## **MEMORANDUM**

**TO:** District of Columbia Zoning Commission

**DATE:** March 21, 2016

**SUBJECT: Public Hearing Report for ZC #08-30C**  
25 M Street, SE – Modification of an Approved Zoning Commission Design Review Under the Capitol Gateway Overlay

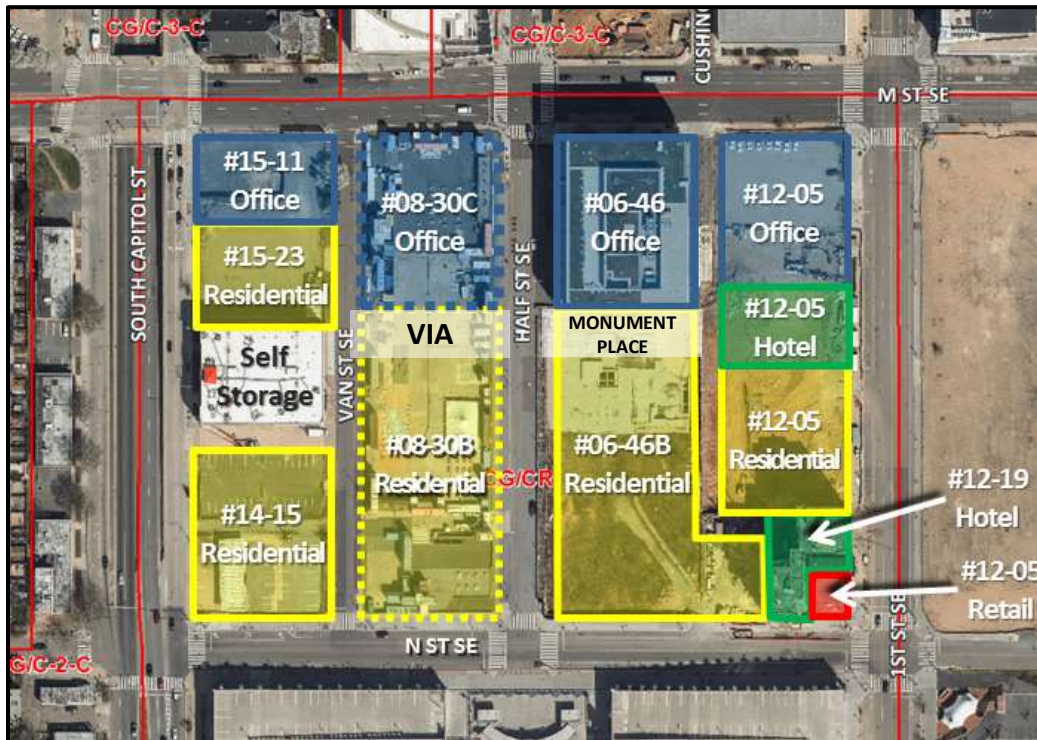
The applicant has applied for a modification to the design of this mixed use development originally approved by the Commission in 2009 and subsequently modified in 2011. This proposal includes a modification to the massing and architecture on the part of the site at M Street SE, north of the Via. The Office of Planning (OP) reviewed the application pursuant to the review criteria of Chapter 16 of the Regulations, the Capitol Gateway Overlay. The application generally successfully addresses the criteria of the Overlay and OP strongly supports the project. OP has requested that the applicant address the outstanding items in this report, and pending resolution of those issues OP would have no objection to the overall application.
